Technical BULLETIN

SAFETY RECALL

CERTAIN 2015~2018-MODEL XC155 (SMAX) SCOOTERS FACTORY MODIFICATION CAMPAIGN – Coolant Enters the Combustion Chamber

Kit Contents:

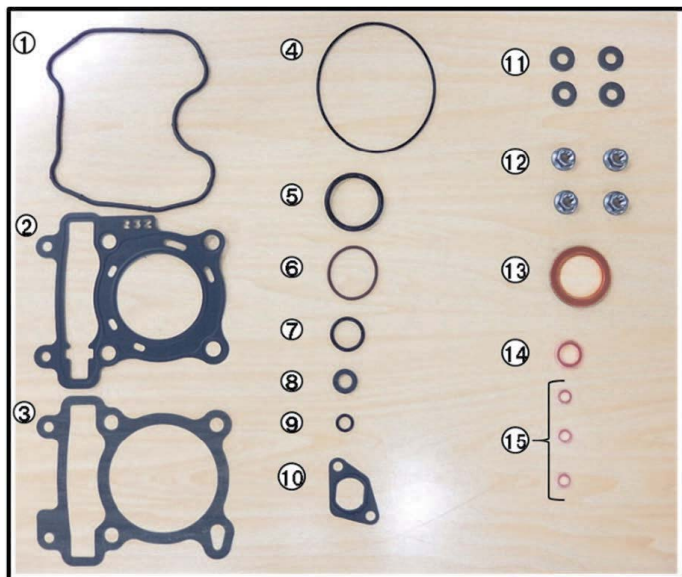
Parts: Yes, replace the affected cylinder head gasket using the new cylinder head gasket kit. See the Parts Information section.

REF.	DESCRIPTION	PART NUMBER
1	Cylinder Head Gasket Kit	52S-E1193-01-00
2	Gasket, Cylinder Head 1	52S-E1181-00-00
3	Gasket, Cylinder	52S-E1351-01-00
4	O-Ring	52S-E2439-00-00
5	O-Ring	93210-32807-00
6	O-Ring	52S-E2439-00-00
7	O-Ring	93210-347A1-00
8	O-Ring	1DK-E2843-00-00
9	O-Ring	4CW-E2223-00-00
10	Gasket, Tensioner Case	4DH-E2213-01-00
11	Washer, Plate	90201-08859-00
12	Nut	90179-08518-00
13	Gasket, Exhaust Pipe	5YP-E4613-00-00
14	Washer, Plate	90201-12172-00
15	Gasket	90430-06014-00
